## **ORDINANCE NO. 1953**

**(An ordinance proclaiming the annexation of certain contiguous territory located within the Urban Growth Boundary—Elan Holdings, LLC.)**

**BEFORE THE CITY OF HOOD RIVER PLANNING COMMISSION  
HOOD RIVER, OREGON**

Before and after view of the SW corner of Tax lot 1804 looking NW from Tax lot 1806.

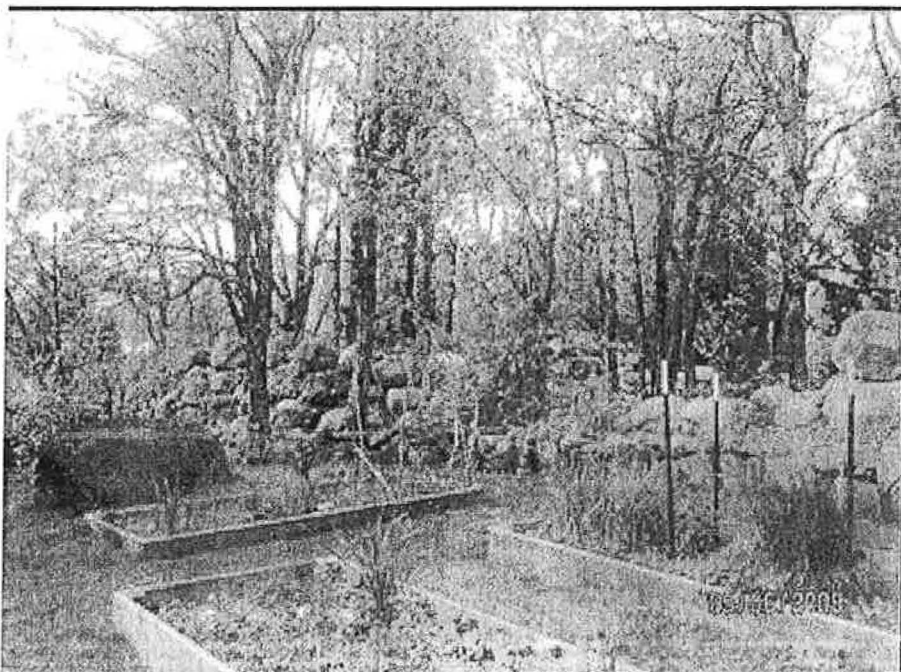
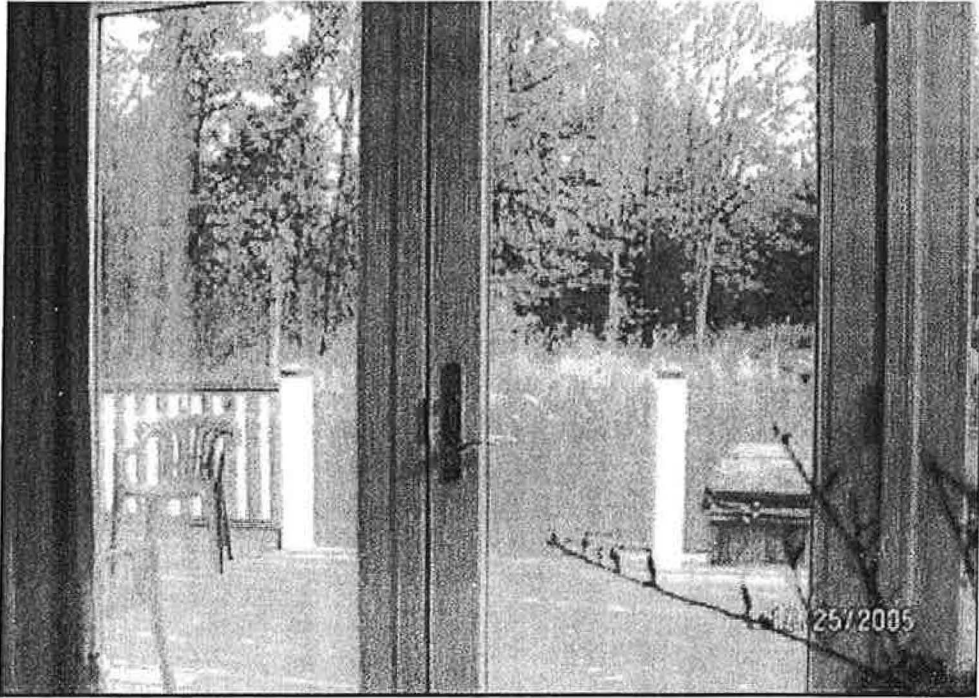
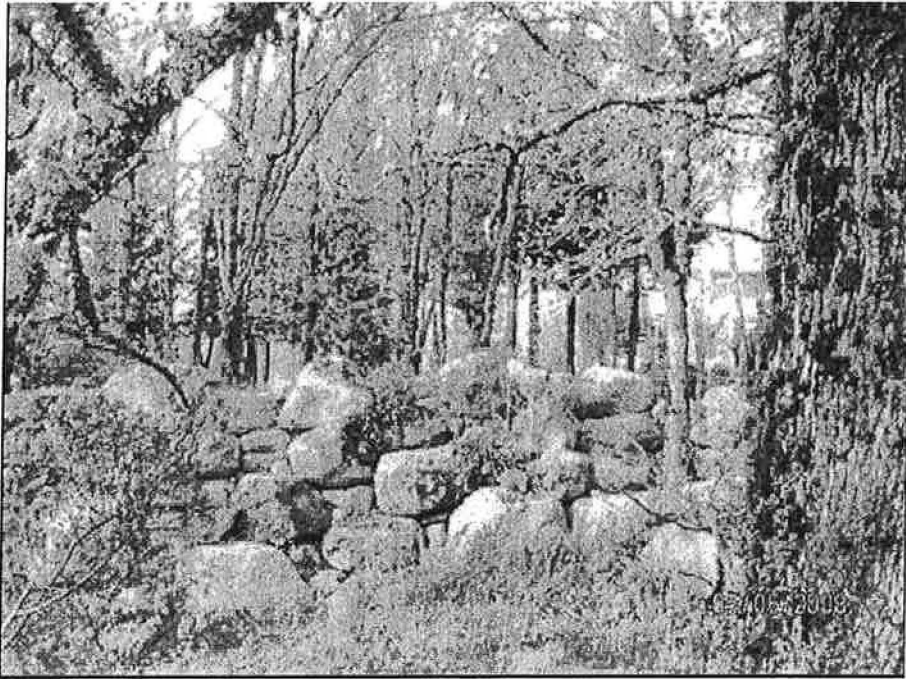
As a reference, I am including some before and after pictures for comparison, and including a few to the northwest where lots 3 & 4 would come together.

This is the corner that contains lot 3 & 4. I am concerned about the retaining wall and about houses being jammed into the lots, out of character with the surrounding neighborhood.

**STREET/GRADING/DRAINAGE PLAN**  
**ELAN ESTATES SUBDIVISION**  
 HOOD RIVER COUNTY, OREGON

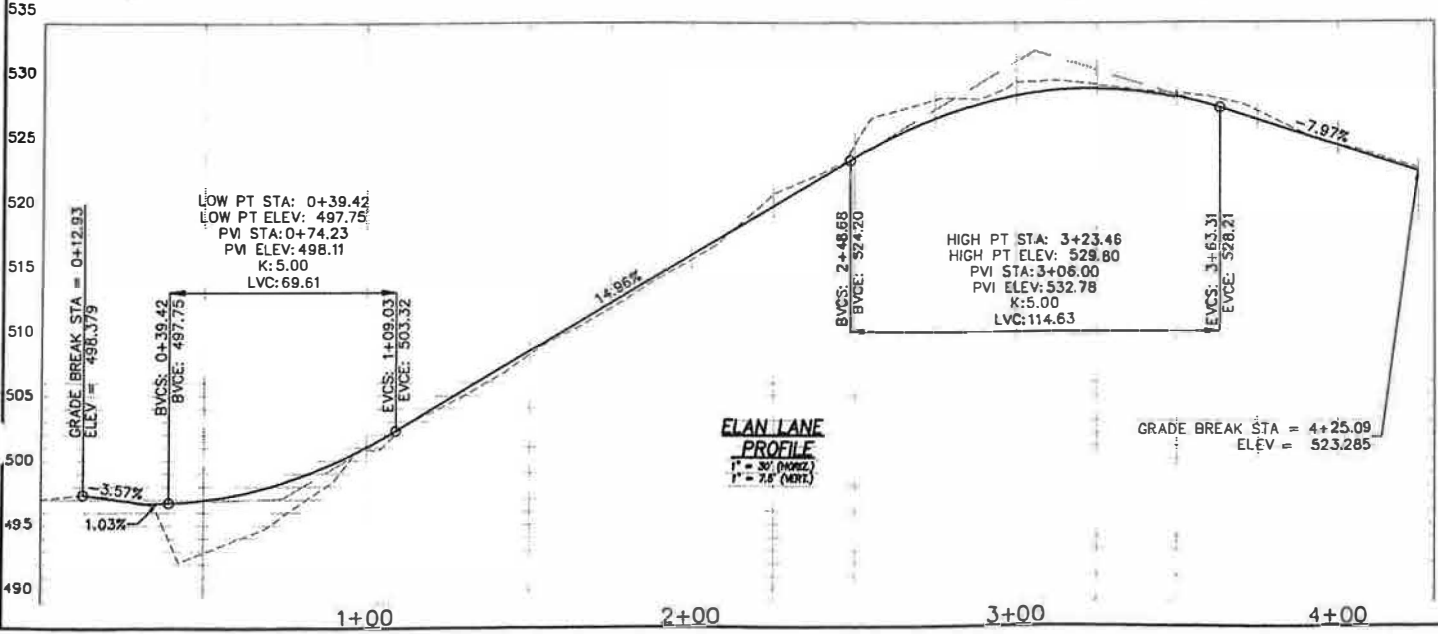
**FINDINGS:** The applicant submitted preliminary storm drainage information (Attachment "A.3", Sheet 4). Neighboring property owners submitted comments (Attachments "F" and "G") expressing concerns about drainage from the site affecting properties to the east of the site, and along May Street. The City Engineering Department requires provision of a stormwater management plan in conformance with the City's Engineering Standards. In addition, **a condition of approval is recommended that stormwater facilities shall be designed to ensure there is no adverse effect on adjacent properties and rights-of-way.** As conditioned, the proposal is consistent with these requirements.

**FINDINGS:** As depicted on the preliminary plans (Attachment “A.3”, Sheet 4), the applicants propose to install street trees along May Street and the new public street approximately 20- to 30-foot-on-center. The applicants indicate that species will be selected from the City’s street tree list. Due to existing trees on the site, the location of driveways, topography and other issues, proposed street tree locations appear to be appropriate. However, **a condition of approval is recommended that prior to final plat approval street trees shall be provided in conformance with HRMC 16.12.050, including a minimum caliper size of two inches. The City Engineer may allow an exception to allow some trees to be planted in association with building permits for the new homes.**

**FINDINGS:** The applicants propose a 32-foot-wide right-of-way to facilitate a street that is similar to a Local Street Infill Standard Option “A” (Attachment “A.3”, Sheet 4). The proposed street includes “on-street” parking located partially within the right-of-way and partially within public access easements on Lots 2 and 6. The applicants assert that this design is appropriate because less than 100 daily vehicle trips are anticipated, including if/when the street is extended west. The applicants also assert that due to existing topography, a street grade is nearly 15% is needed for a distance of less than 250 feet.
